CROSSROADS NORTH

PRELIMINARY PLAN

COVER
SHEET 01 OF 14

PRELIMINARY PLAN / LANDSCAPE STANDARDS

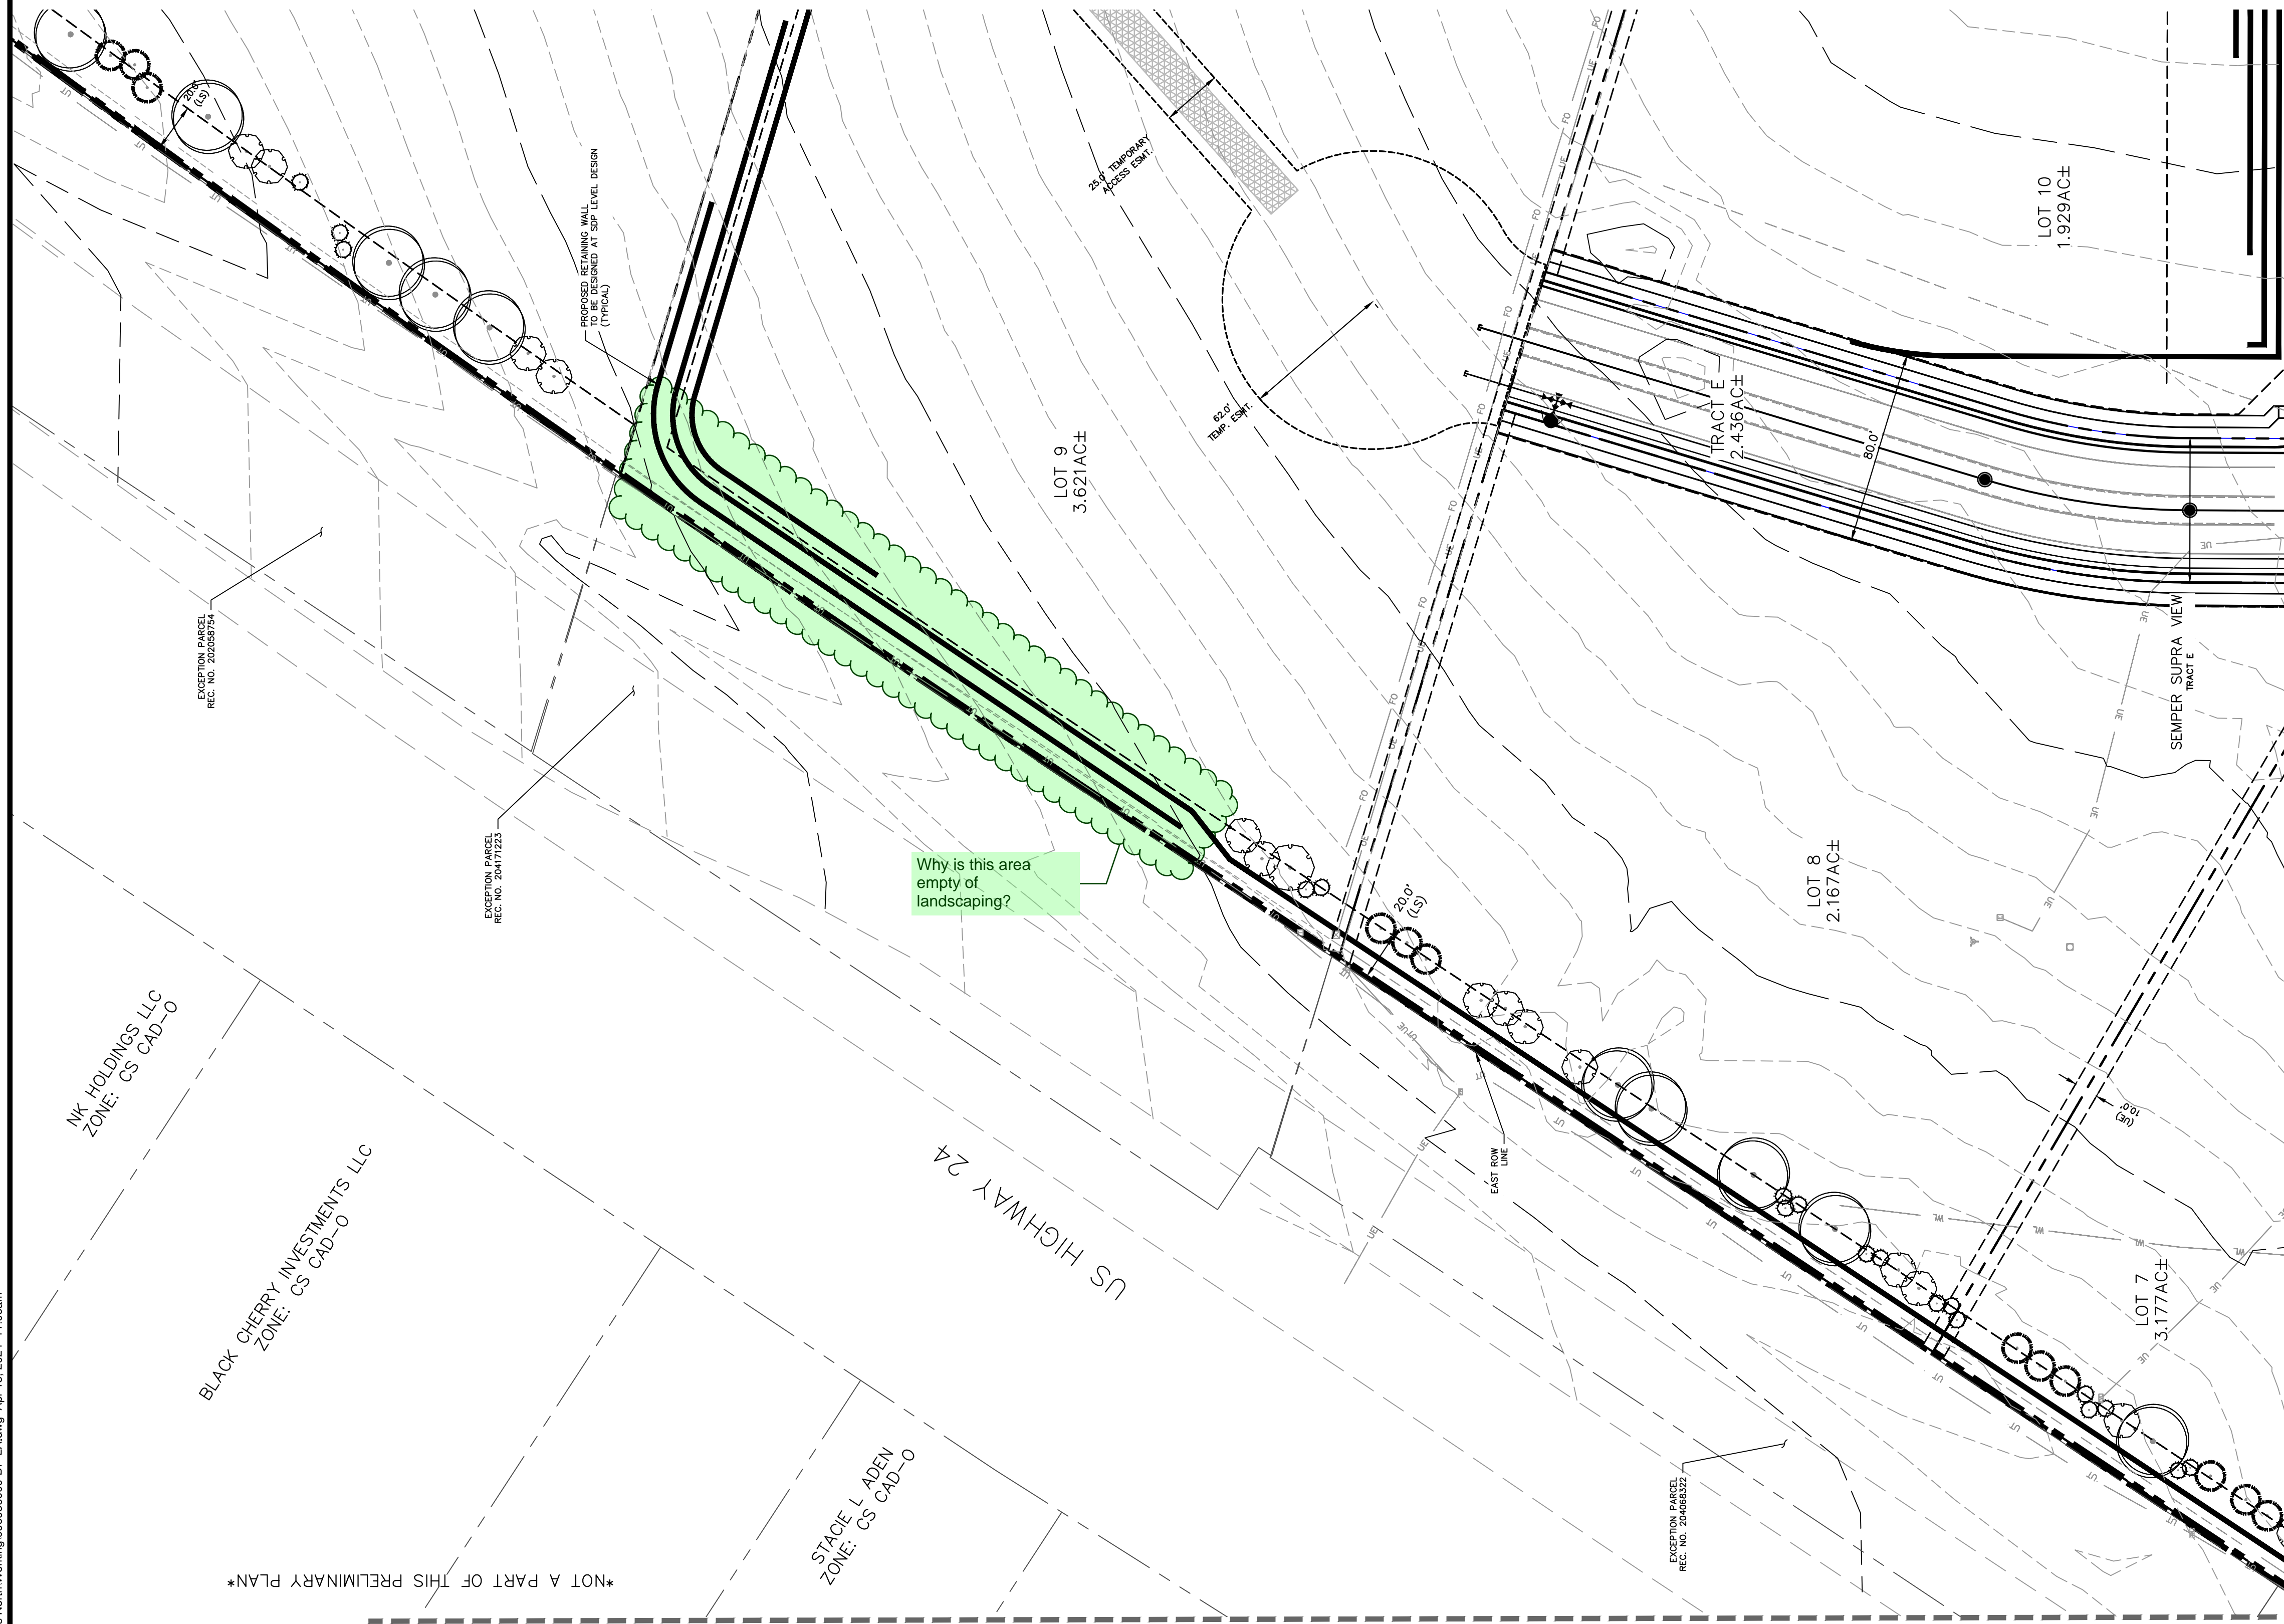
Since this is not a PUD, you are not required to illustrate roadway landscaping for the private sites/PCD strongly encourages, however, that you design and detail as much as possible at the preliminary plan stage to facilitate high quality development of the site, and so landscaping will not be piecemeal as the sites come in to develop. I recommend establishing roadway landscaping for the entire subdivision as a master landscape plan, such that when individual sites come in for site development plan review, their landscaping is consistent with the buffers provided here, and the internal landscaping will be reviewed on a lot by lot basis.

That being said, the public areas and the roadway landscaping that is developer responsibility should be detailed now.

You have included most of the landscape pages back that were missing on the previous submittal. However, it appears that pages are still missing - there was an overall sheet that illustrated the entire property, and I am not seeing any landscaping on the internal roads - just the perimeter buffer.

Roadway landscaping is required per LDC Sec. 6.2.2.B.

You are also referring to Tract A as "primary open space and landscape" on page 2 of the PUD plan set; however, this area is not illustrated on any of the landscape sheets, along with the internal road network with required landscaping. I recommend either providing a landscaped "park" plan at this stage for the tract, or indicate that a separate site development plan application in the future will be provided for the park site (which is required anyway) and detailed landscaping will be provided at that time.
